Technical Service Bulletin (TSB)
Service Hybrid Electric Vehicle System Warning Message

REFERENCE:	TSB: 08-116-25 REV. A GROUP: 08 - Electrical	Date:	May 22, 2025	REVISION:	08-116-25
VEHICLES AFFECTED:	2023 - 2025 (JL) Jeep Wrangler This bulletin applies to vehicles built on and before October 14, 2024 (MDH 1014XX) equipped with 2.0L I4 DOHC DI Turbo Engine W/ESS (Sales Code ECX).			MARKET APPLICABILITY: ☒ NA☐ MEA ☐ SA☐ IAP ☐ EE☐ CH	
CUSTOMER SYMPTOM:	Customers must experience a Malfunction Indicator Lamp (MIL) illumination and the vehicle must exhibit/set the following Diagnostic Trouble Code (DTC): - B273C-00 - Digital Crash Input. NOTE: Technicians may find the DTC is stored or pending in the Hybrid Control Processor (HCP). Customers may experience one or more of the following: - The "Service Hybrid Electric Vehicle System Warning" message and Light are displayed in the Instrument Panel Cluster (IPC) Fig. 1. NOTE: This message may be displayed for a few seconds and then disappear. - The vehicle may no longer enter Electric or Hybrid drive modes.

This bulletin supersedes Technical Service Bulletin (TSB) 08-116-25, date of issue April 12, 2025, which should be removed from your

Fig. 3
Ferrite Bead Assembly

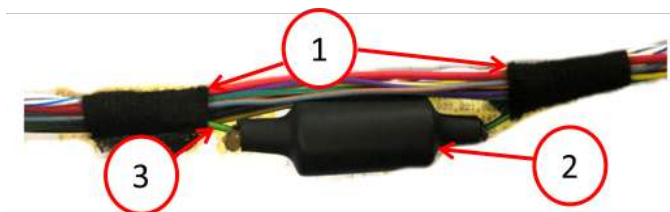
8. **Carefully remove** the harness protective tape from D8119E to the remaining stud clip 1107 [Fig. 2](#) from the wire harness.
9. Locate R414A in cavity 16, located in connector D8119E [Fig. 2](#) and remove the dark green/beige circuit wire [Fig. 3](#).

10. Place circuit R414A through the ferrite bead and install the ferrite bead **between clips 1107 and 1108** [Fig. 2](#) and [Fig. 3](#).
11. Install two butyl patches around wire circuit R414A at both openings of the ferrite bead [Fig. 3](#).

12. Place Heat Shrink tube over circuit R414A and ferrite bead [Fig. 3](#).
13. Using a heat gun, heat the heat shrink tubing around ferrite bead, ensuring sealant flows out of each end tubing [Fig. 3](#).
